UNITED STATES PATENT AND TRADEMARK OFFICE

APPLICATION NO.	FILING DATE	FIRST NAMED INVENTOR	ATTORNEY DOCKET NO.	CONFIRMATION NO.
10/049,597	02/14/2002	Francis Mouyen	49316/280551	9713

Office Action Summary

DETAILED ACTION***Claim Rejections - 35 USC § 103***

Figure 1 - U.S. Patent 4,995,062 to Schulza-Ganzlin et al.

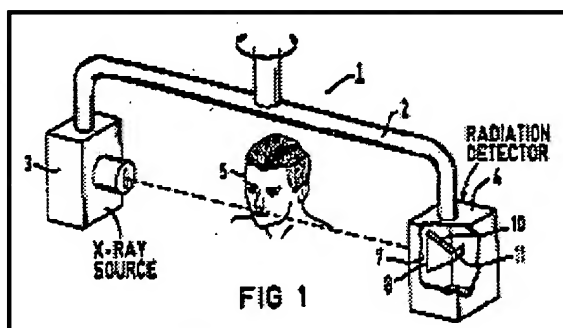
5. As per claim 1, Schulza-Ganzlin et al. disclose a method comprising the steps of emitting a bundle of X-rays in the direction of a tooth and its surrounding area and guiding the X-rays that emerge from the tooth and its surrounding area; transforming X-rays into light rays of a greater wavelength than that of X-rays (Fig. 2, #9; column 3, lines 5-6); converting these light rays into electrical signals and processing these signals to produce radiographic data (abstract). Schulza-Ganzlin et al. do not explicitly disclose the step of guiding emerging X-rays into substantially cylindrical rods substantially along the axis of the volume.

31. Applicant contends that the cited references teach away from each other. Applicant cites the disclosure of Schulza-Ganzlin et al. as relating to the use of a transmission or coupling element ((10)- see Fig. 1 above), such as fiber optics (column 3, lines 1-11). Applicant supports the position that the disclosures are divergent by also citing in Mouyen ('798) that the method

32. Examiner notes however, that Schulza-Ganzlin et al. in describing the invention give an illustrative example of a transmitting or coupling element, of which fiber optics can be used. Examiner treats the disclosure of element (10) as not being limited only to fiber optics, but encompasses any elements that could satisfactorily provide/ possess a transmitting or coupling function (see also Schulza-Ganzlin et al. column 7, lines 54-59). Examiner further notes that the cylindrical rods of Mouyen possess transmitting/coupling capabilities. Therefore, examiner concludes that the coupling element of Mouyen may reasonably be applied to the method and apparatus of Schulza-Ganzlin et al. and the aforementioned references do not teach away from each other as they are in agreement with regards to transmitting/coupling elements.

Figure 4 - U.S. Patent 4,995,062 to Schulza-Ganzlin et al.

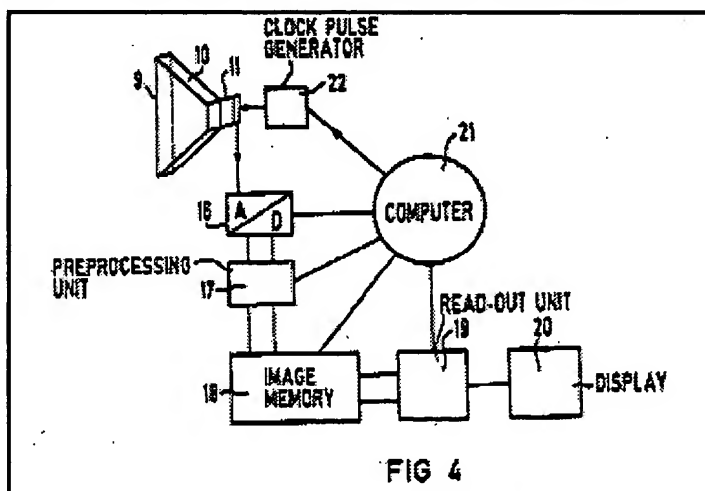
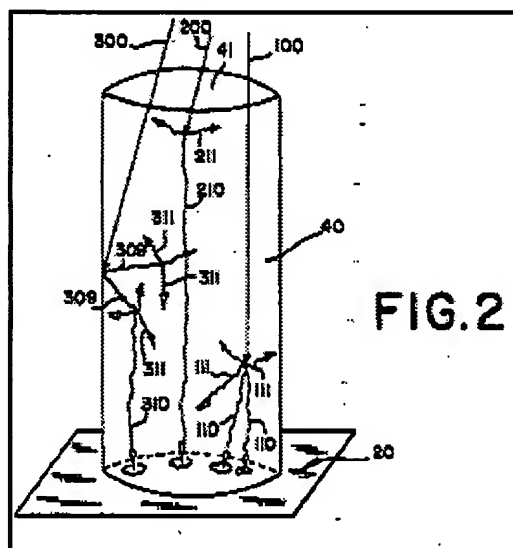
11. As per claim 3, Schulza-Ganzlin et al. as modified above, disclose a method comprising converting light rays into analogue signals and subsequently into digital electrical signals (Schulza-Ganzlin et al.; Fig. 4-16)

15. As per claim 6, Schulza-Ganzlin et al. as modified above disclose an apparatus configured to convert light rays into analogue signals and a converter for converting analogue signals into digital signals (see Schulza-Ganzlin et al.; Fig. 4-16).

16. As per claim 7, Schulza-Ganzlin et al. as modified above disclose an apparatus comprising a CCD bar (see Schulza-Ganzlin et al.; Fig. 4-11) for converting light rays into analogue signals. Schulza-Ganzlin et al. do not explicitly disclose an apparatus comprising a CAN converter for converting analogue signals into digital signals.

Figures 1 and 2 - U.S. Patent 5,382,798 to Mouyen

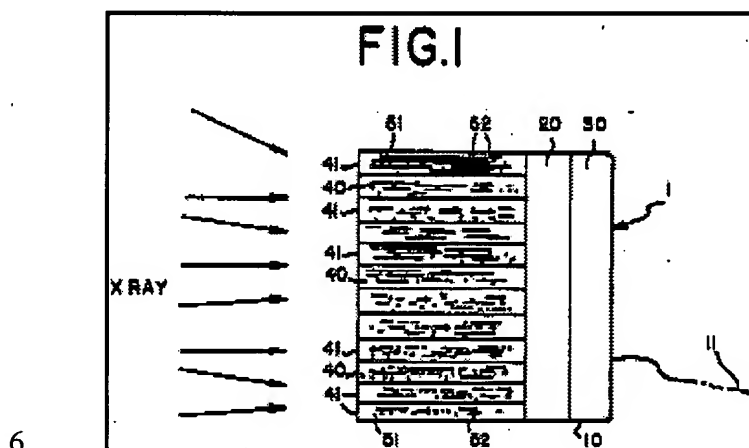
7. Mouyen discloses a method comprising the step of guiding emerging X-rays (200) into substantially cylindrical rods (40) substantially along the axis of the volume. Mouyen teaches that guiding emerging X-rays results in the formation of high quality pictures (column 1, lines 36-41).

8. It would have been obvious to modify the method of Schulza-Ganzlin et al. such that it incorporated the step of guiding emerging X-rays into substantially cylindrical rods substantially along the axis of the volume. One would have been motivated to make such a modification so that received radiation is used to form high quality pictures, by reducing diffuse radiation as taught by Mouyen (column 1, lines 36-41; column 3, lines 51-63).

36. Figures 2 - U.S. Patent 5,382,798 to Mouyen

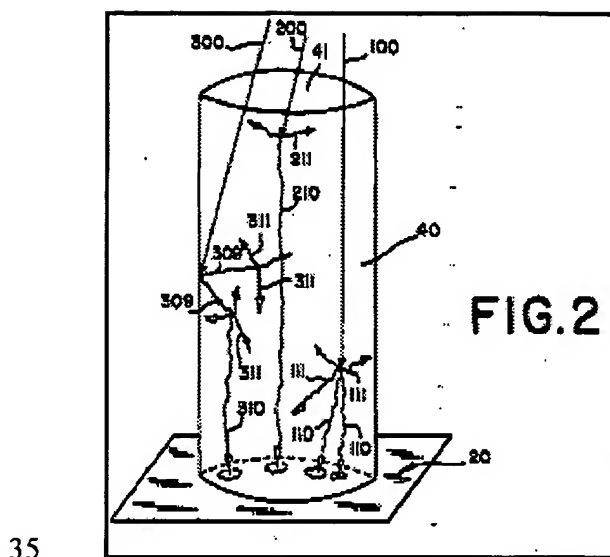
37. Mouyen ('798) – Fig. 2, teaches the interaction of radiation beams (100, 200 and 300) as they pass through an object of interest and traverse through cylindrical rod (40) and enter the face of a receiving sensor (20). It is noted that the Mouyen ('798) teaches that diffuse or secondary rays (200) or lateral primary rays (300) that enter cylindrical rod (40) do not (and will not) contribute significantly to the formation of an image as their energies are absorbed while traveling through the rod. However, Mouyen teaches that only primary rays (100) that enter rod (40) substantially along the rod's length-wise axis will contribute significantly to image generation (see Mouyen ('798) – column 3, lines 1-39).

38. Examiner contends that Applicant's conclusion is based only with regards to rays 200 and 300, and has failed to address the treatment of primary ray 100. Examiner further contends that in radiation imaging it is often the non-oblique beams that contribute to sharp image generation (i.e. less cross talk among detection elements, resulting in sharper image contrasts and higher image definitions).
